RENESAS TECHNICAL UPDATE

Product Category	Application specific IC	Document No.	TN-ASP-A019A/E	Rev.	1.00
Title	M66592/M66596 Usage Precautions of the Buffer memory initialization by the ACLRM bit	Information Category	Technical Notification		
Applicable Product	USB ASSP M66592/M66596	Lot No.	Reference Document	M66592 data sheet (REJ03F0111) M66596 data sheet (REJ03F0119)

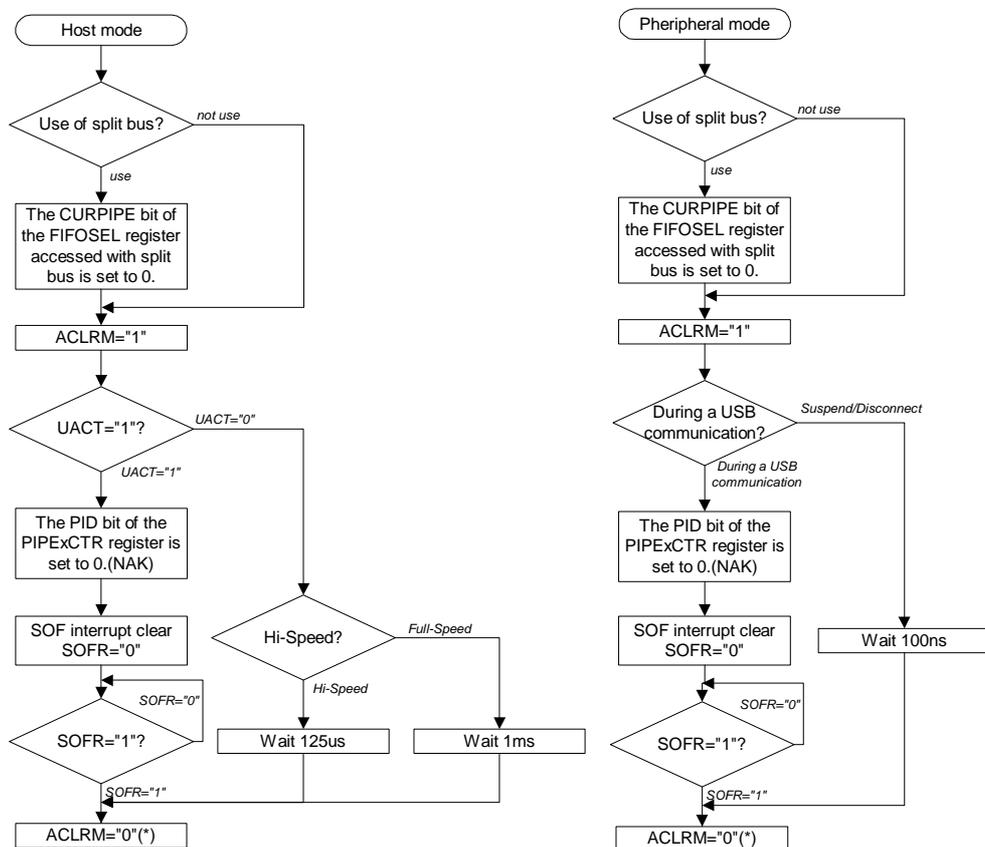
1. Phenomena

This precaution concerns the Buffer memory initialization by the ACLRM bit.

When the conditions described in [2. Occurring Conditions] below are met, the Interrupt status of the pertinent pipe cannot operate properly. Also, this precaution is independent on Peripheral mode / Host mode.

[1. Phenomena] described above may occur when condition 1 is present at the same time as condition 2 or 3.

Condition 1: The ACLRM bit is set to "1" and then to "0".

Condition 2: During a USB communication (The SOF sending and receiving is included).

Condition 3: During an access by using Split bus.

This phenomenon can be avoided by using the following software flowchart.

* Set ACRM bit to "0" within 125us after change from SOFR = "0" to SOFR = "1".
